Test Report No.: EW0071-3

5. APPENDIX A – MODIFICATIONS RECORDERS FOR ENGINEERING CHANGES TO THE EUT BY THE LAB

The Bevi Countertop 1.0 Needed the Following Modifications to Pass Radiated Emissions:

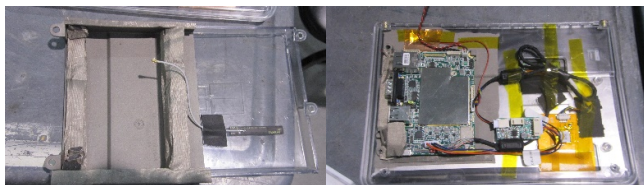
One Ferrite on the Touch Screen Cable PN: 0461178181
